ADDENDUM #1
TUNNEL MANHOLE
REHABILITATION F/Y 24-1
CONTRACT #2024-22
REGIONAL WATER RESOURCE AGENCY

DATE: October 28, 2024

MH #1234

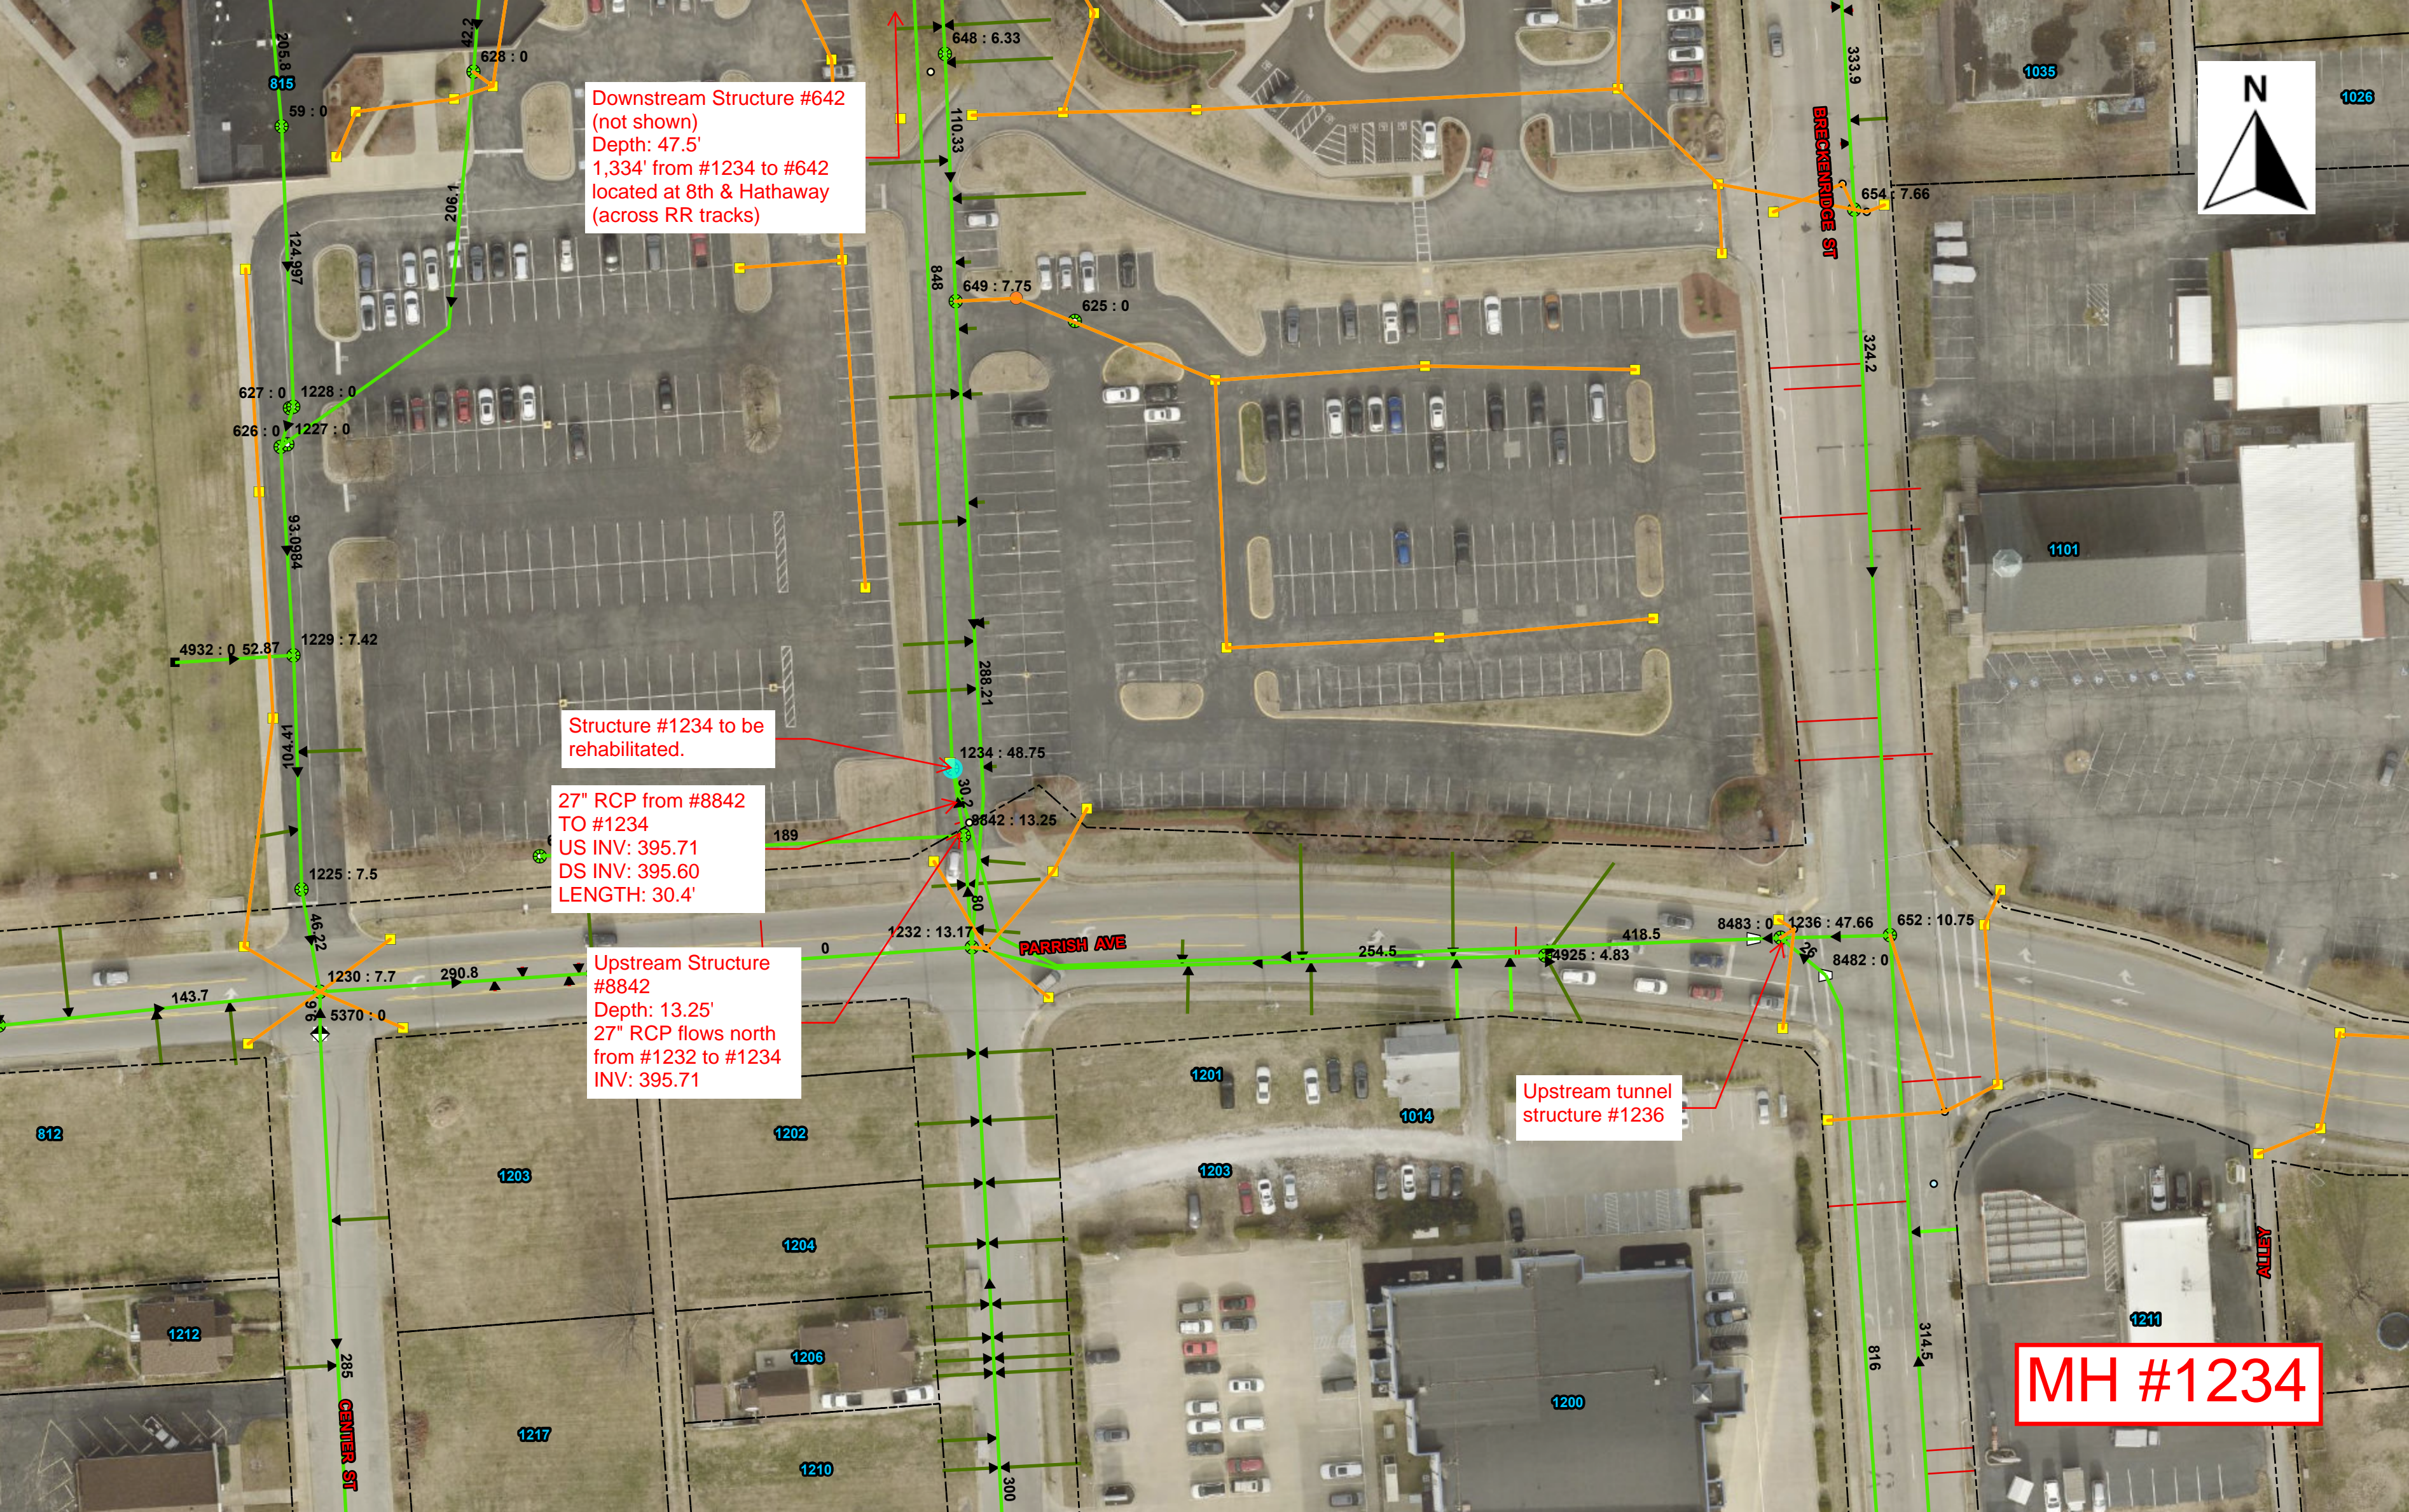
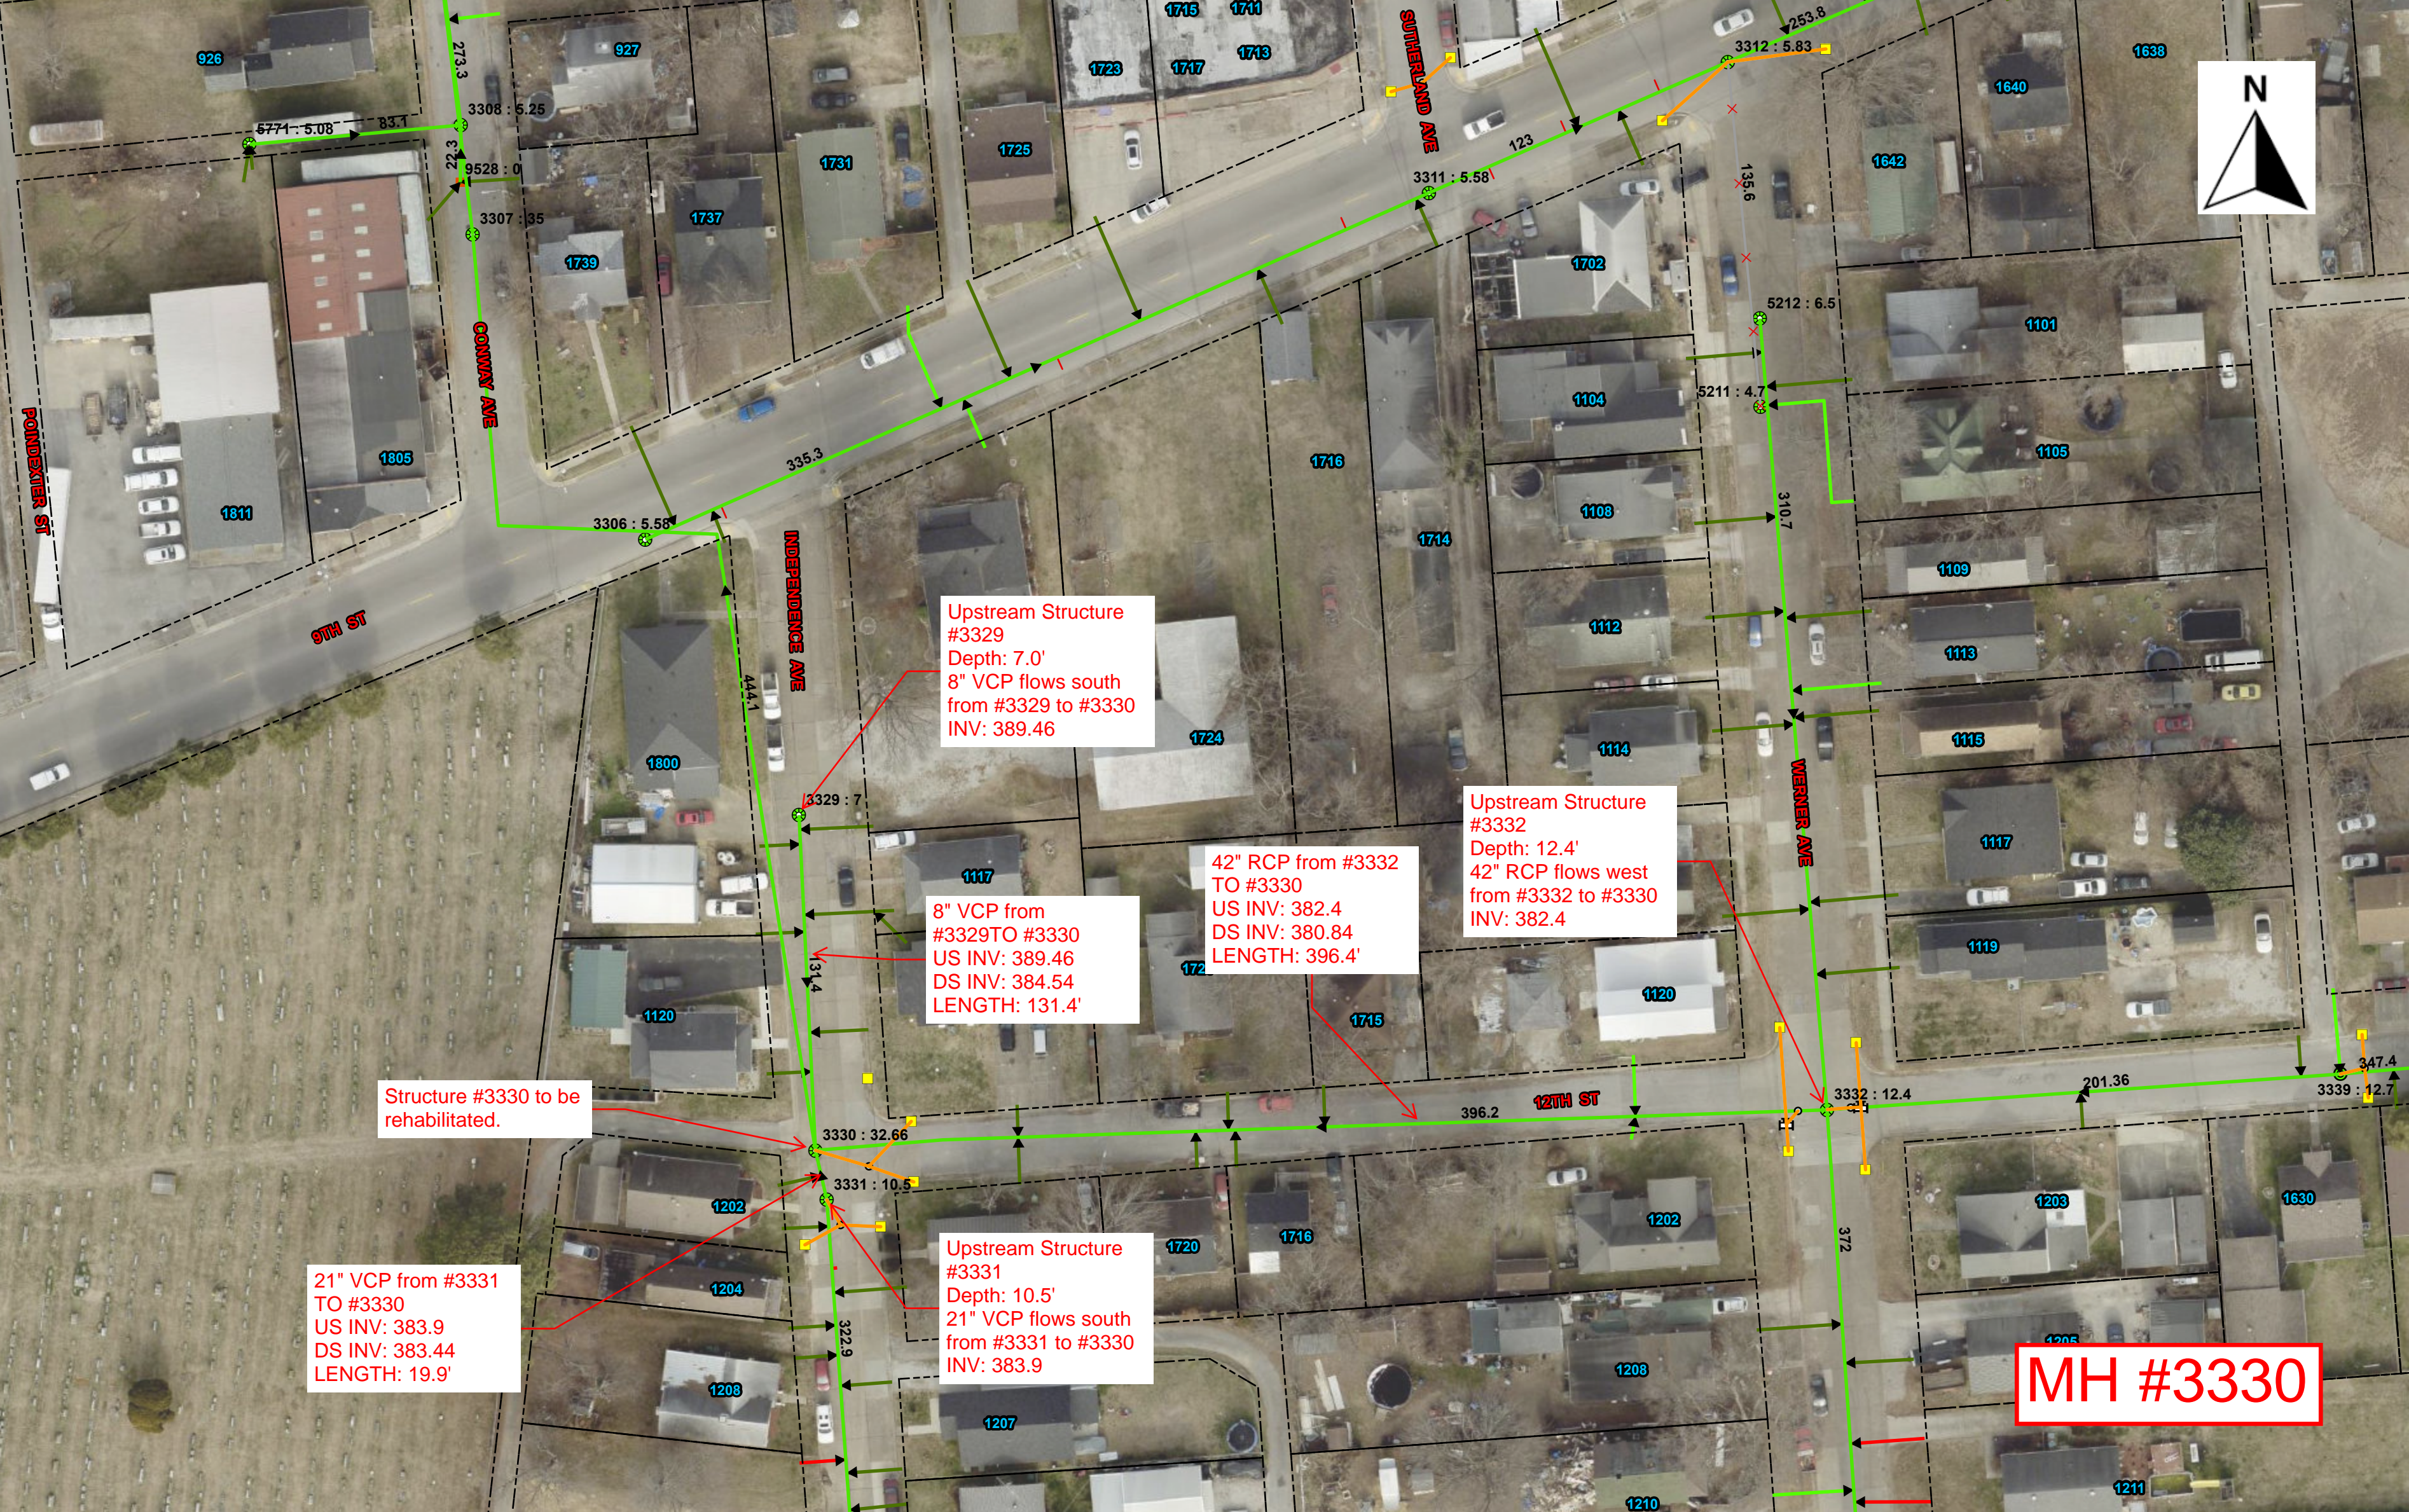
5. **Can RWRA provide more information regarding the system around the work structures to assist in developing bypass plans?**

6. **Can RWRA provide slopes of the pipes to be bypassed?**

- 16. Is there any way of picking up the flow up stream to prevent the need to have bypassing internally?**

RWRA has created a new set of maps for each structure that includes upstream and down stream tunnel structures, as well as depths, lengths, slopes, etc. of incoming pipes. These maps are included as an appendix to this Addendum #1. All information provided on these maps are for reference purposes only. Contractor shall verify all information.

Structure #1234 to be
rehabilitated.

27" RCP from #8842
TO #1234
US INV: 395.71
DS INV: 395.60
LENGTH: 30.4'

Upstream Structure
#8842
Depth: 13.25'
27" RCP flows north
from #1232 to #1234
INV: 395.71
